Application for Licence Amendment

| Licence Number | L6266/1991/10 |
| Premises | Broome South Sewage Facility 34 Clementson Street MINYIRR WA 6725 Lot 1639 on Plan 184761 and Lot 512 on Plan 409418 As defined by the map in Schedule 1 of this Licence |
| Date of Report | 13/09/2022 |

Figure 2: Process flow diagram

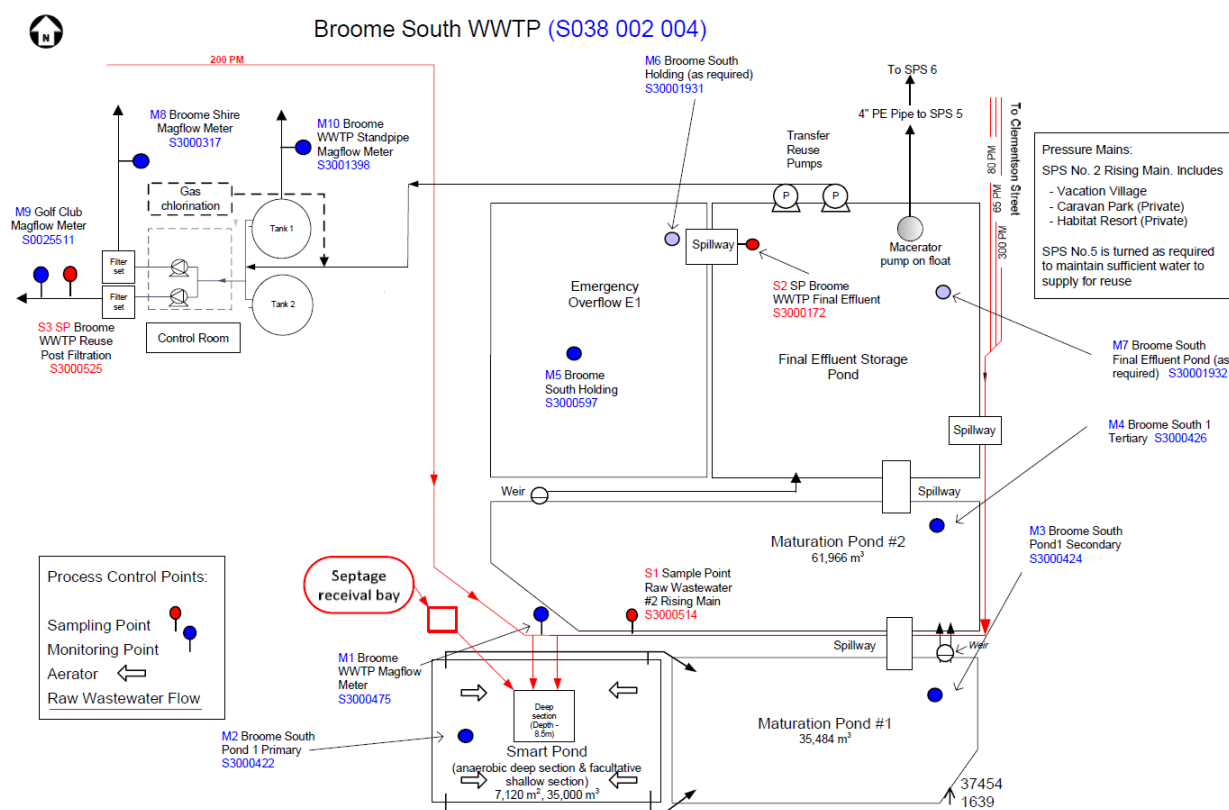
| Condition | Summary of Licence Holder's comment | Department's response |
|--|--|--|
| Schedule 1 Process flow diagram and monitoring points | Process Flow Diagram in Schedule 1 requires update. Water Corporation sent an updated diagram to DWER on 25 May 2022. | The diagram used in the licence is the diagram supplied to the department on 25 May 2022. No change made |
